Reviewer 1

Review of "A North Sea in situ evaluation of the FitchWind Farm Parametrization within the Mellor–Yamada–Nakanishi–Niino and 3D Planetary Boundary Layer schemes" by Agarwal et al. The manuscript compares a new planetary boundary layer scheme to the standard one used for wind farm modeling in WRF. It evaluates the accuracy of the PBL schemes with offshore measurements of two independent sources. A thorough analysis is carried out with respect to model setup and statical metrics.
This work addresses an understudied, yet extremely relevant aspect of mesoscale wind farm modeling. However, several aspects of the manuscript need major improvement before acceptance.

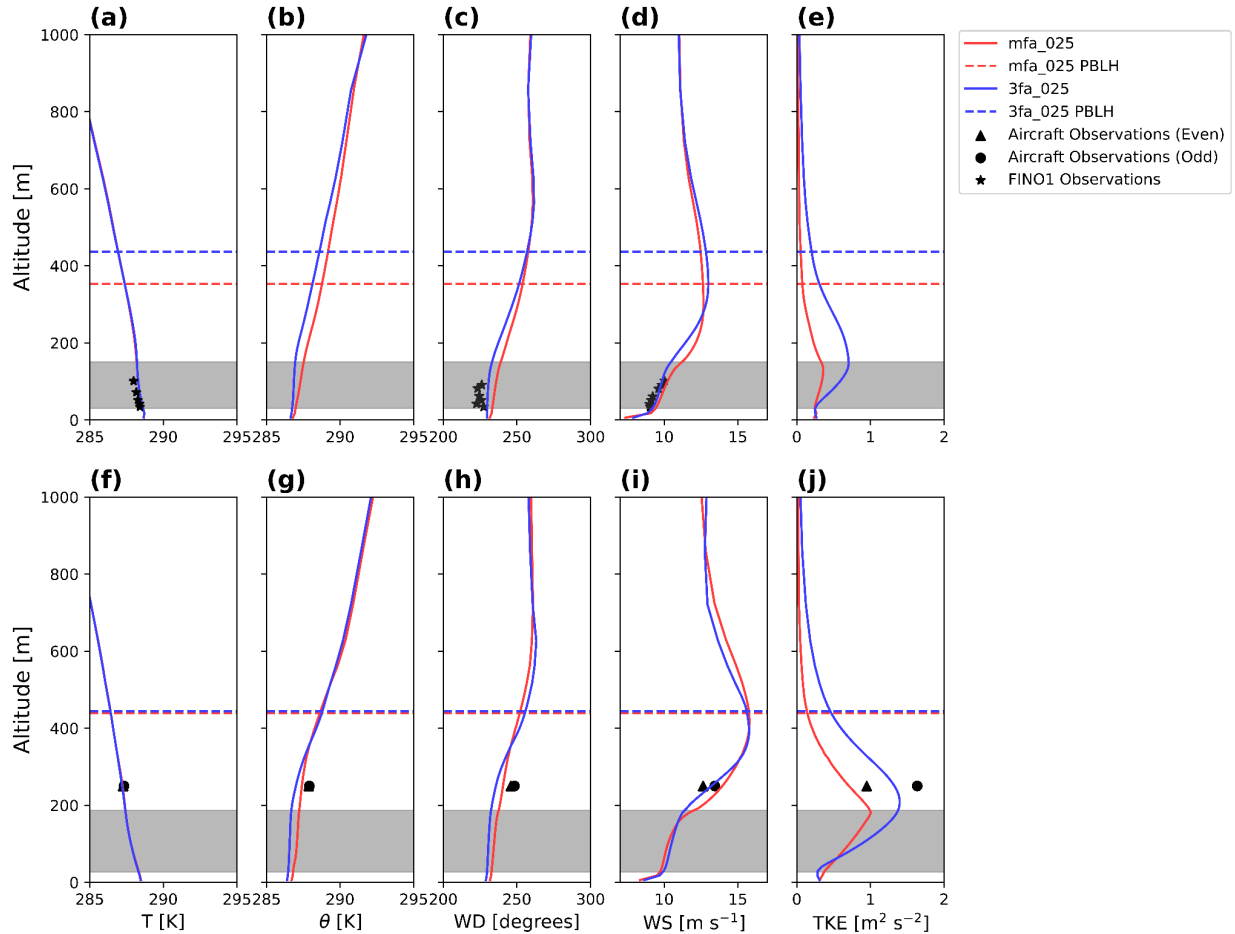
- *Fig. 5: why are no measurement added here? Or alternatively, why not use the NWF runs for a cleaner analysis of the profiles?*

- *L. 244: Add PBLH as reference*

We thank the reviewer for their suggestion. Reviewer 2 similarly suggested that we validate the stability profiles with observations. To address this concern, we have:

- **Added available temperature, wind speed, and wind direction observations for the FINO1 site in the relevant (now Fig. 4) figure**
- **Added available temperature, potential temperature, wind speed, wind direction, and TKE observations for the aircraft transect site in the relevant (now Fig. 4) figure**

Thank you for this comment. We have added PBLH to both our vertical profiles (Fig. 4 and Fig. 5) as shown above.

Figure 9. Time series of 76 m modeled horizontal wind speeds (WS) compared to 81 m FINO1 observations for the hours of 12:00:00–00:00:00. Both the modeled wind speeds and observed wind speeds are resampled to 30 minutes.

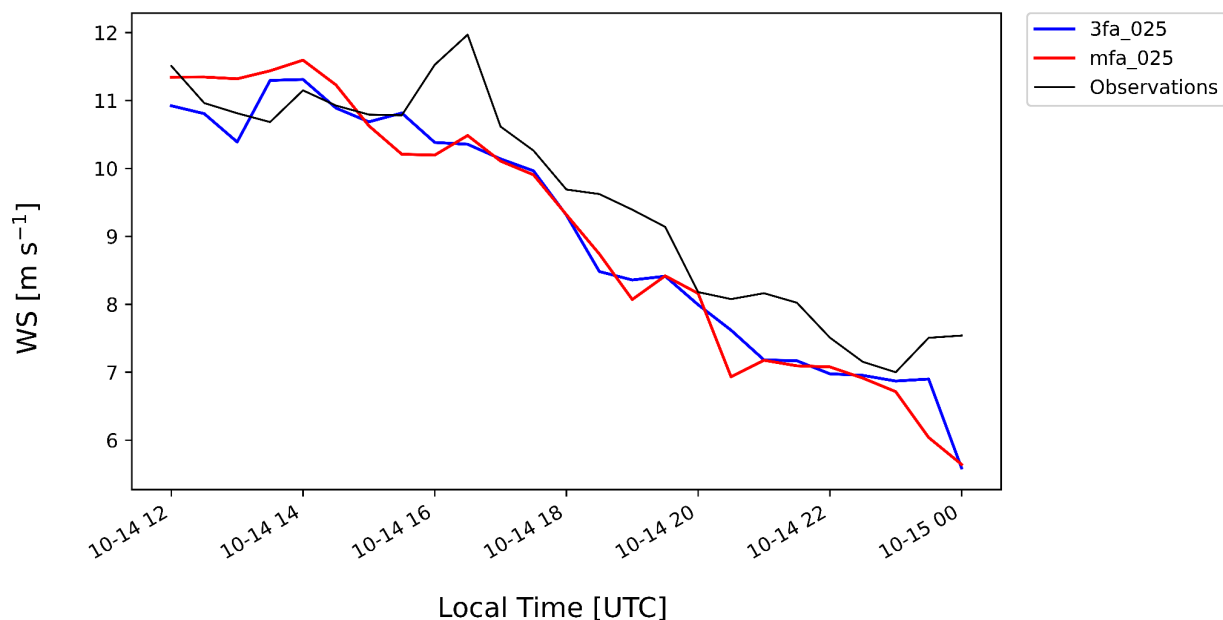
- *Fig. 8: unclear what the mean values are*

Thank you, we acknowledge the lack of clarity in this figure, now Fig. 9. Reviewer 2 has similarly expressed confusion about this plot. By focusing on only one wind farm TKE factor, we hope that this figure is now easier to interpret.
